Limited Visual Dam Safety Inspection Summary Report

MA-058

Honokowai Reservoir

Limited Visual Dam Safety Inspection Conducted on: 07 April 2006

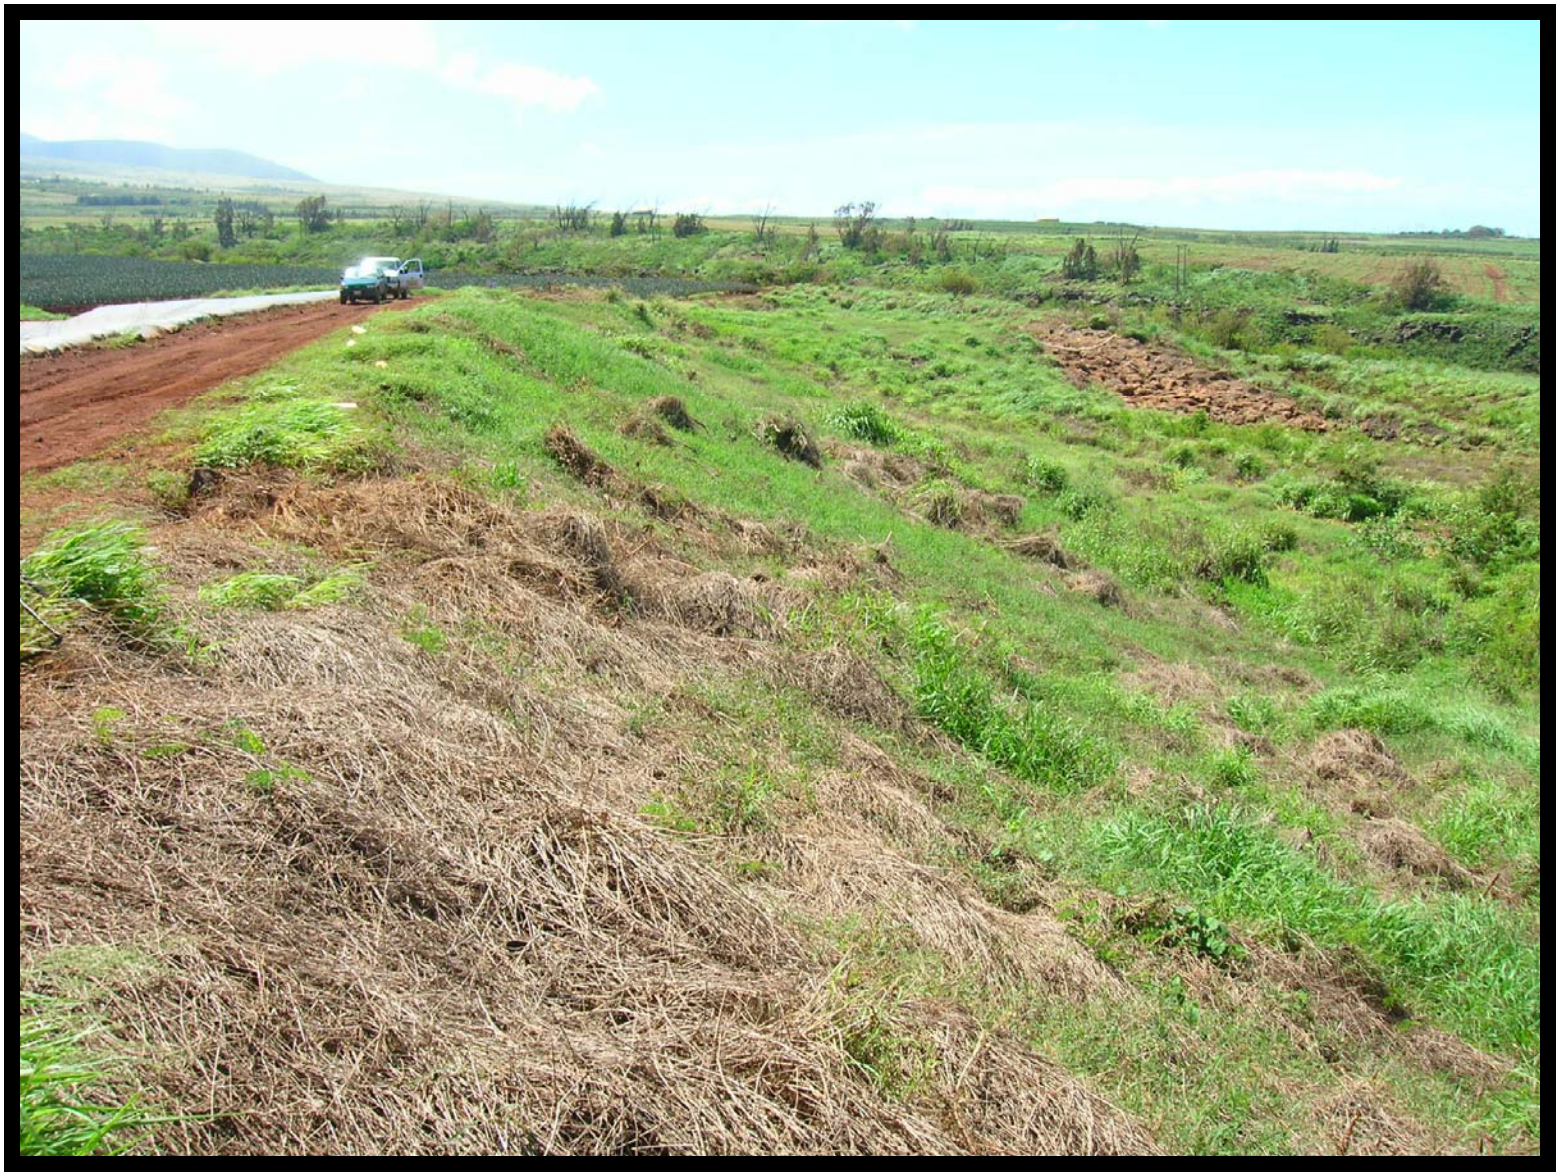
058 View of the downstream slope of the dam. Note the tall grass covering the slope. The grass should be kept short.

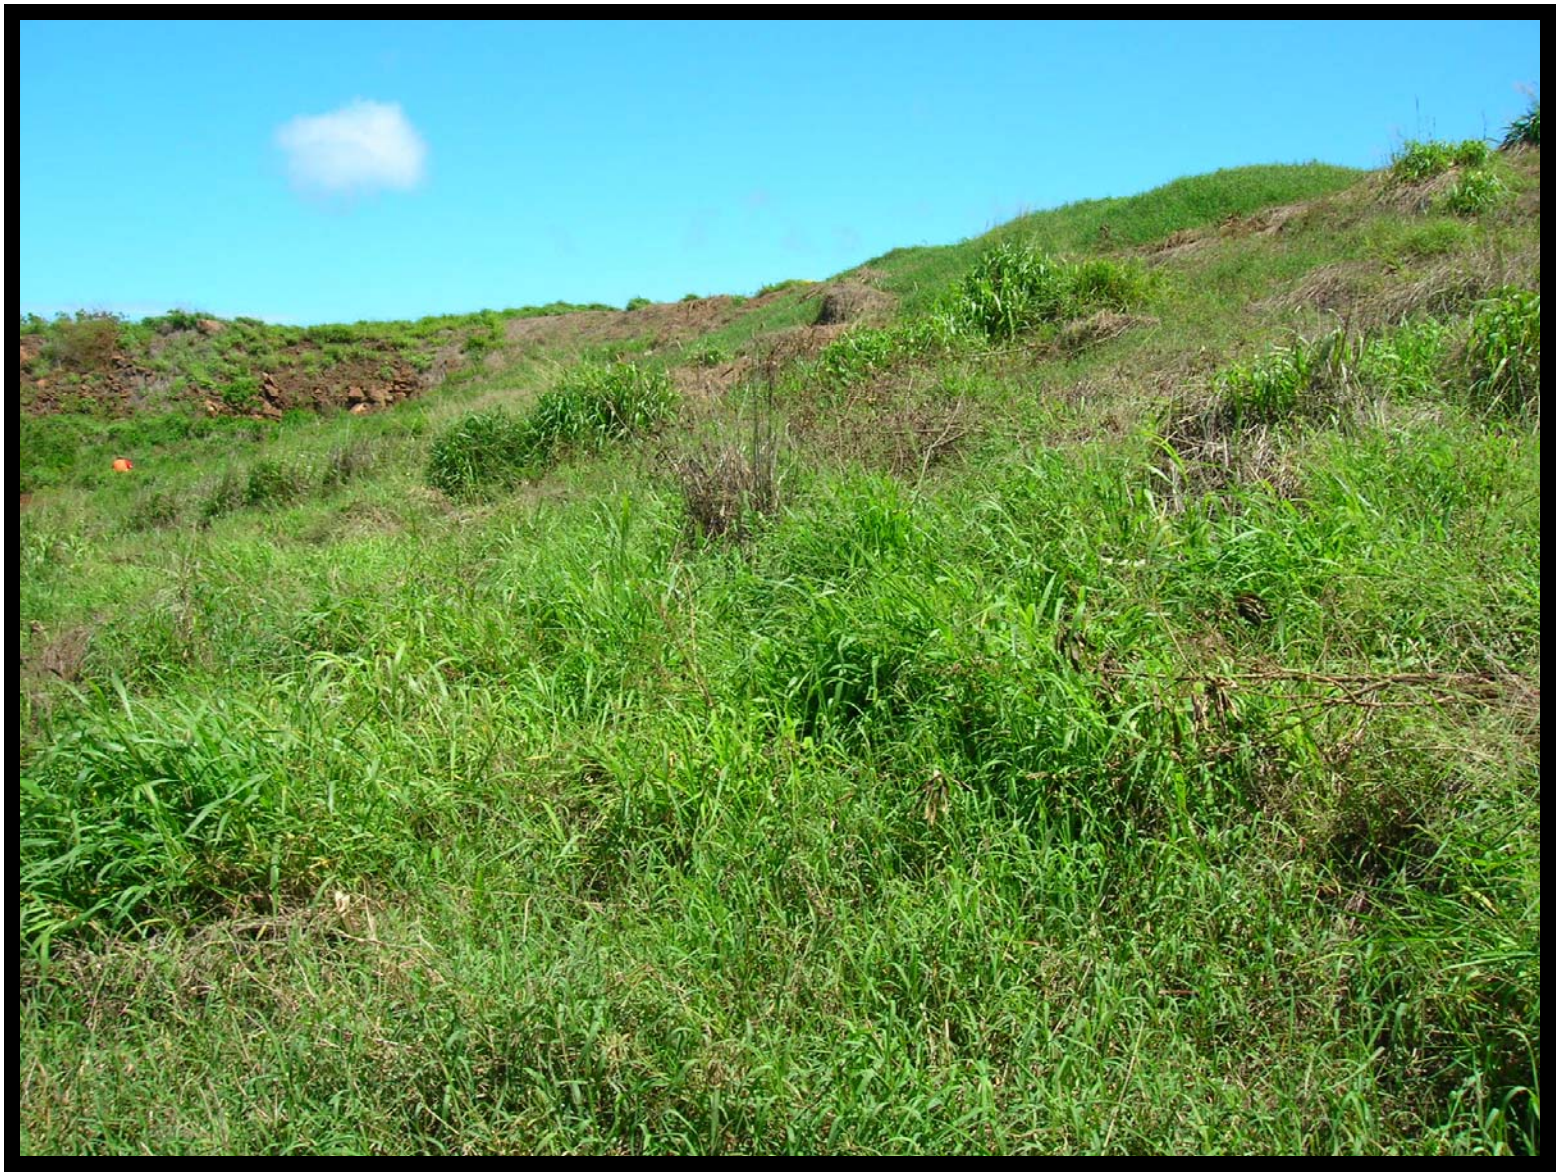
058 View of the downstream slope of the dam. Note the tall grass covering the slope. The grass should be kept short.
